April 18, 2024

Re: Comments on the Draft Programmatic Environmental Impact Statement for Utility-Scale Solar Energy Development (DOI-BLM-HQ-3000-2023-0001-RMP-EIS)

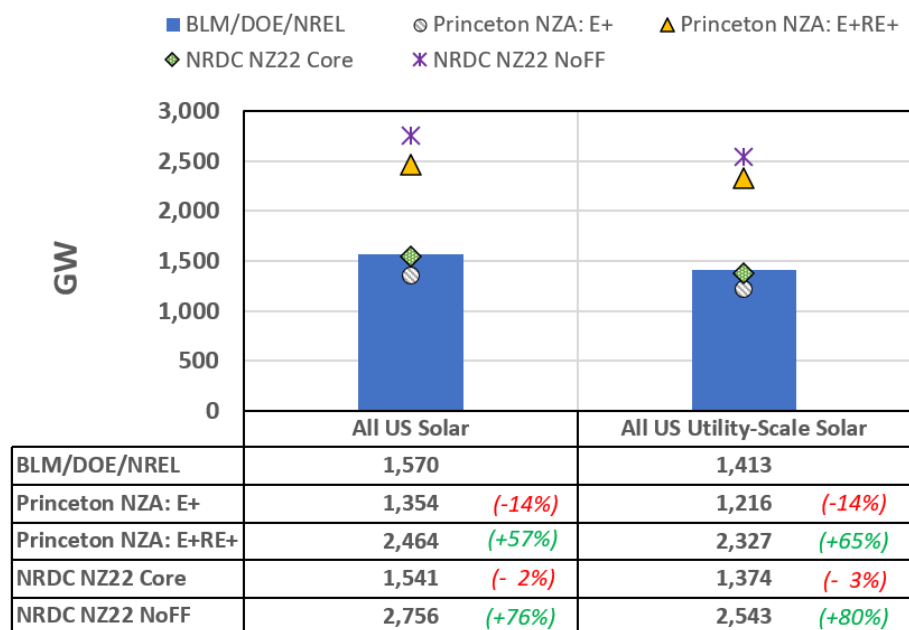
At the national scale, we observe that BLM's level of solar deployment (GW) is in strong alignment with both Princeton's and NRDC's central case net zero scenarios: falling within 15% and 3% of their E+ and Core scenarios, respectively. However, looking to the more aggressive renewable deployment scenarios from these net-zero models calls into question whether BLM's estimate should be considered an upper end estimate. Princeton's E+RE+ scenario shows ~60% more solar being deployed nationwide through 2050 and NRDC's NoFF scenario shows ~80% more through 2050. This suggests that BLM could be underestimating total deployment overall.

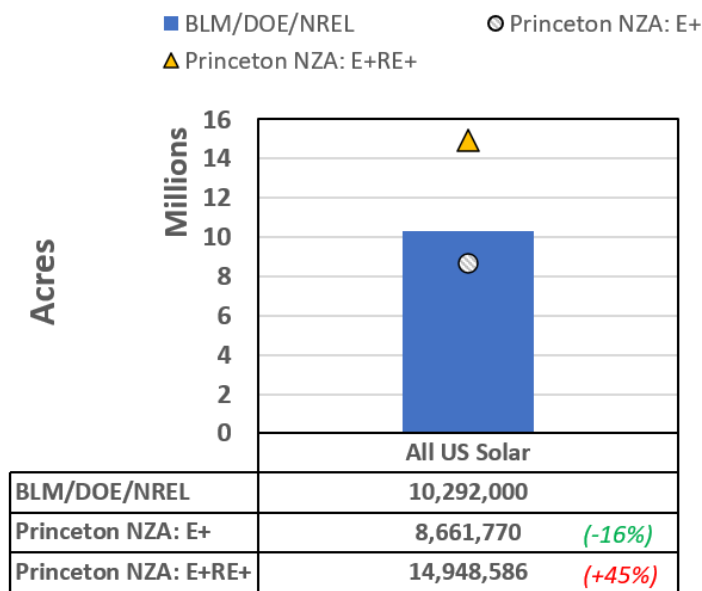
The same observation holds true when comparing BLM's total acreage needs from the DOE Solar Futures Study to net-zero studies at the national level. We observe a significant difference, with Princeton NZA predicting 45% higher acreage need for solar nationwide in its ambitious renewable-driven E+RE+ scenario through 2050, but also note this deviation is

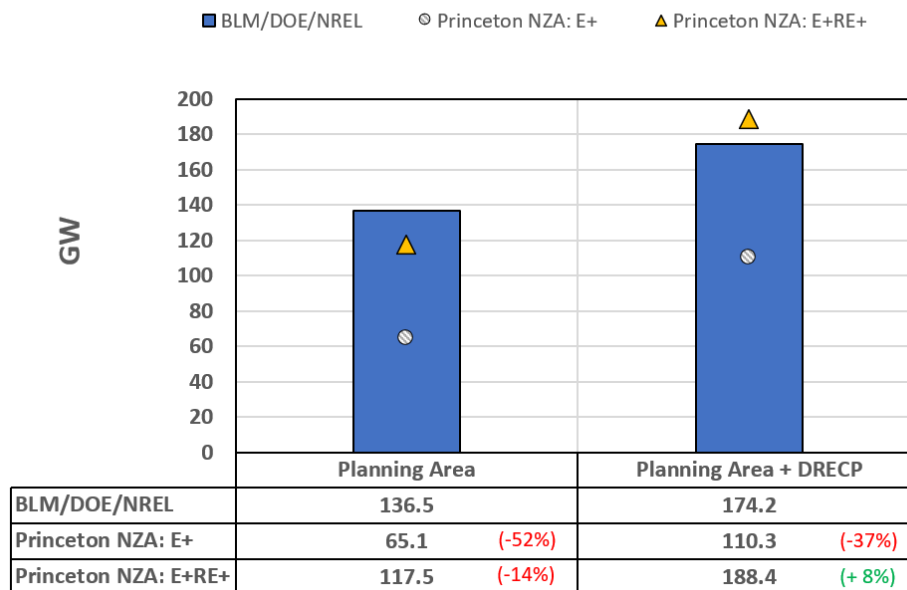
Figure 3 shows the total solar deployment in planning area states. If we assume the same share of California solar is deployed in the DRECP under Princeton’s modeling as in BLM’s own assessment, we find that, despite the potential higher-level underestimation suggested by nation-wide data, the planning area match is fairly good with even the most ambitious net-zero modeling scenario. This alignment also appears fairly robust to the default assumption on share of California solar, landing within +/-15% of BLM’s deployment totals for the E+RE+ scenario in either view: 65 to 118 GW in the planning area and 110 to 188 GW in all 11 states. Notably, however, if the DRECP is included, the ambitious net-zero scenario deploys 8% more solar than BLM predicts, which again, technically calls into question the idea of this as an upper-end limit, but certainly supports the idea of it representing an upper-end estimate.

Figure 4. Planning area land needs for solar deployment, comparing estimates of acreage for BLM’s scope (“Planning Area”) and the full eleven states, including BLM’s scoped-out DRECP within California (“Planning Area + DRECP”).

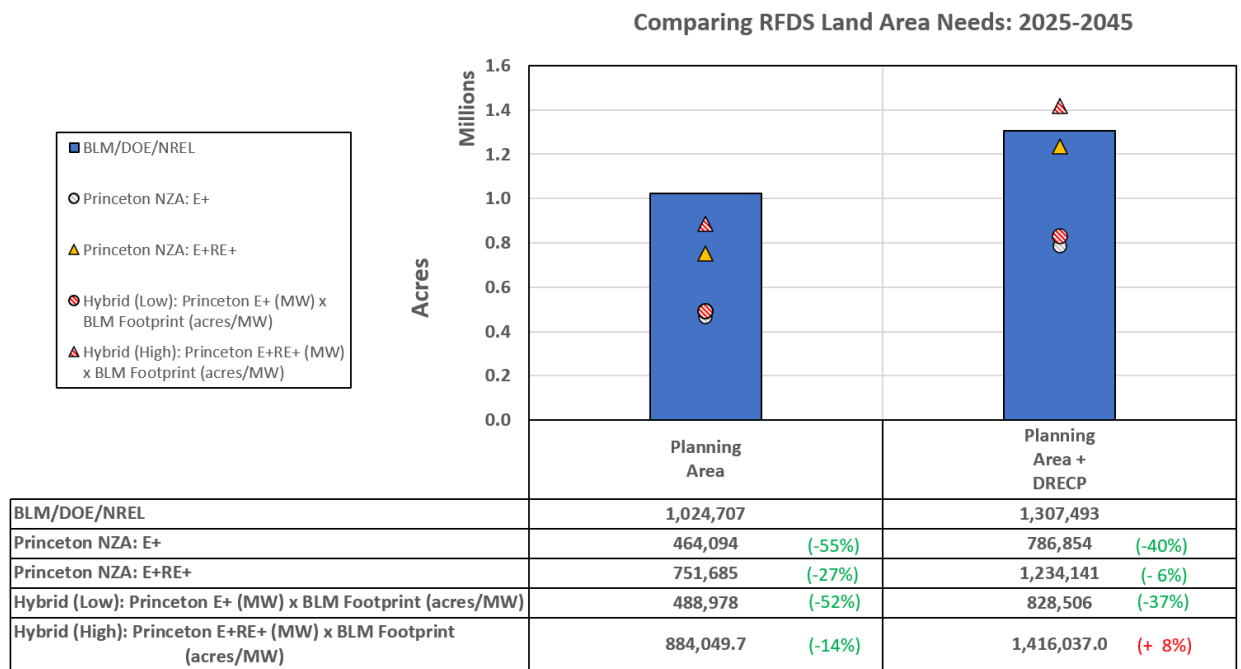
Similarly, Figure 4 shows the total acreage estimates for utility-scale solar in the planning area region covered by this PEIS. Again, despite potential for national-scale underestimation, we find the planning area acreage estimates are fairly consistent with BLM’s totals whether California’s DRECP is included or not, implying differing degrees of reliance on western states between *Solar Futures* and *NZA*. BLM’s data totals 1.02 million acres through 2045 for the planning area proper (inclusive of BLM-managed lands and lands outside of BLM’s jurisdiction)—excluding DRECP—whereas estimates from downscaling of Princeton state-level data suggests 27-55% less, at 464 to 752 thousand acres, depending on the specific net-zero scenario and its reliance on solar. In contrast to the deployment level comparison in Figure 3, acreage estimates from the net-zero study are all beneath BLM’s predictions for the planning area, whether or not it includes the DRECP. This is because, for the same reason noted in the national scale data in section A, the underlying solar footprint used by Princeton is lower than BLM’s source and results in systematically lower land use predictions for the same level of solar deployment. For this reason, it is also important to consider how this known difference in underlying drivers of acreage estimates—namely, the solar footprint (acres/MW) assumed by each study and levels of solar deployed (MW) it gets applied to—are biasing results in ways that prevent apples-to-apples comparison, and we include two additional “hybrid” scenario datapoints in Figure 4 to demonstrate that.

The results of harmonizing assumptions between the studies²⁹⁶ are labeled “Hybrid (low)” and “Hybrid (high)” in Figure 4, and they represent using deployment data from Princeton’s E+ and

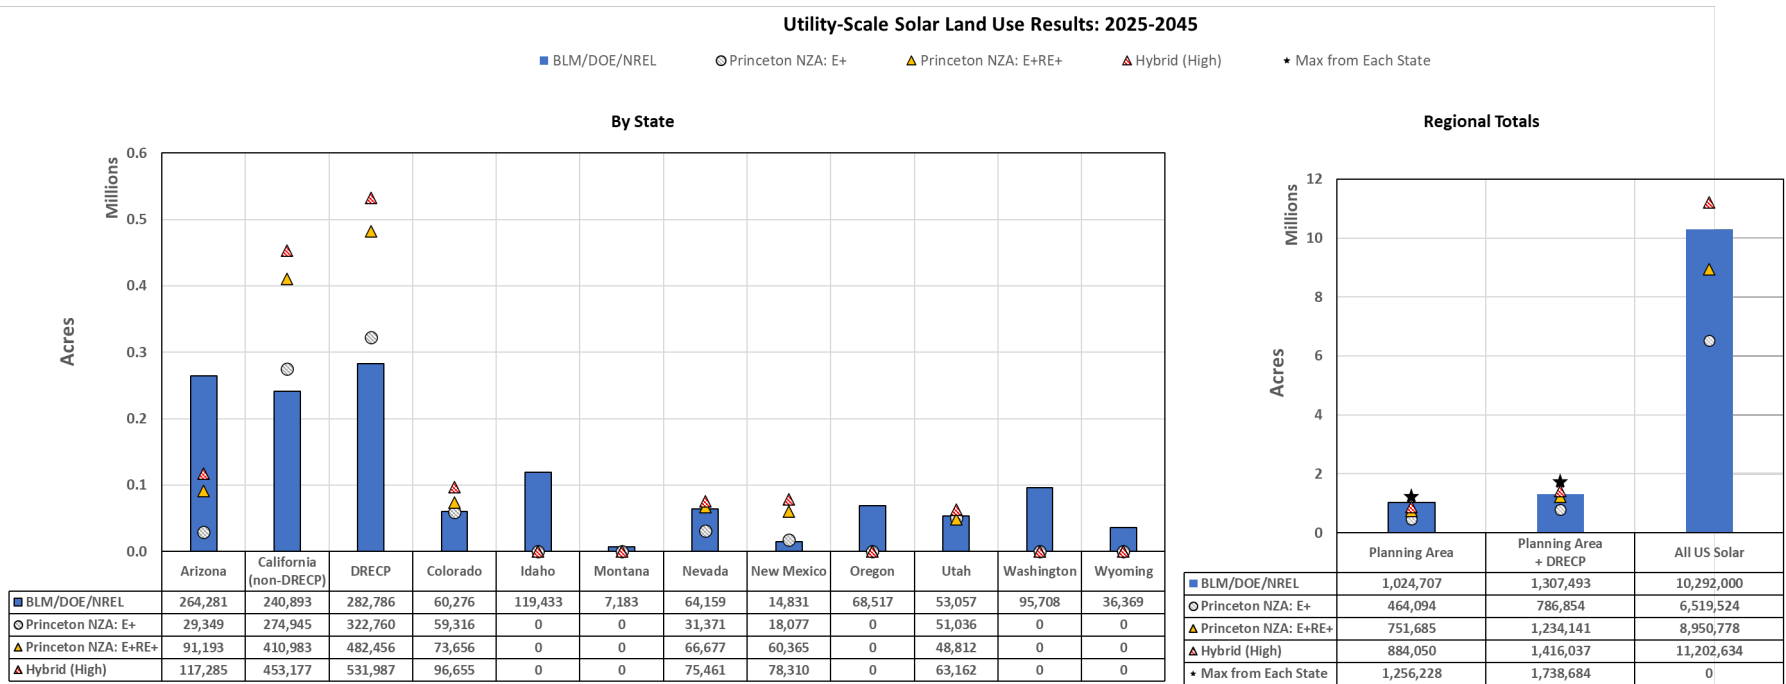
Table 3 and Figure 6 show the corresponding land area expected to be needed to meet the deployment through 2045 in planning area states, for the most direct final comparisons to the RFDS. Given the direct relationship between deployment and land use, the directional changes by state are consistent with those described in the prior paragraph; however, the magnitudes vary for the six states NZA predicts to see development in. New Mexico, California, and Colorado see the largest discrepancies, suggesting BLM is potentially underestimating acreage requirements in these states by as much as 3x, 1.8x, and 22%, respectively, if NZA modeling assumptions of solar footprint are taken to be representative. If expanded to combine BLM solar footprint assumption with Princeton's deployment levels, this discrepancy grows to 4.3x, 2x, and 60% for New Mexico, California, and Colorado, respectively.

Figure 7. Illustrative excerpts from Princeton NZA’s Appendix on deriving PV footprint or power density

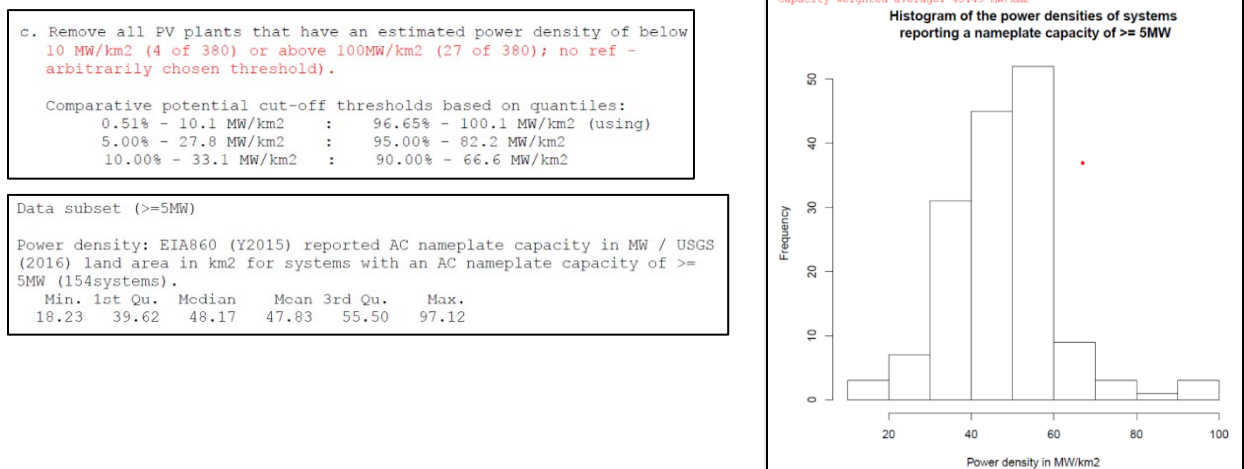
If these alternate sources are indicative of future improvement, BLM could be significantly overestimating the amount of area needed. If, for example, IEA’s lower bound footprint of 2.5 acres/MW was theoretically more accurate for the bulk of future utility-scale solar projects deployed through 2045 than the upper range of 8 acres/MW cited by BLM, then BLM’s RFDS could hypothetically be overestimating area by as much as 70%, all else held equal. However, while future efficiency improvements should be anticipated pushing new systems in the direction of less area per unit of installed solar power being needed, existing evidence about today’s systems can illustrate how extreme a departure IEA’s 100 MW/km² upper bound would be. To that end, the most transparent data source—Princeton’s NZA report—offers a more comprehensive look at frequency of different levels of power density for solar projects in their Annex D. There, authors document the process of coming to their central estimate of 45 MW/km², or the 5.5 MW/acre noted above, for solar projects, key data points of which are shown in

Figure 7. They reviewed data on over 350 projects from USGS and EIA databases of existing solar projects and found that <7% (27 of 380) had power densities at or above IEA’s upper bound of 100 MW/km² (below 2.5 acres/MW). They instead opted for the weighted average value of the remaining dataset, finding that to be 45 MW/km² (5.5 acres/MW), which they characterized as “on the high end of the range [of comparable outside estimates], but considered reasonable due to recent industry trends such as increasing nameplate power rating for photovoltaic panels.” This would suggest that BLM’s estimate is not likely to be more than 26-47% off, in the direction of overestimate, for land area estimates if modeling the same amount of solar deployment in its relevant net-zero scenarios.
